Notice of Allowability

10/758,289

PELLIZZER et al.

Examiner's Amendment

Fig. 1
(PRIOR ART)

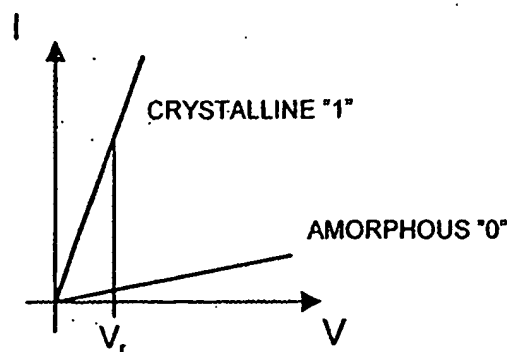
1. An examiner's amendment to the record appears below. Should the changes and/or additions be unacceptable to applicant, an amendment may be filed as provided by 37 CFR 1.312.
FIGURES: Figures 1-3, 5, and 6 have been labeled "Prior Art" (as they illustrates prior solutions)
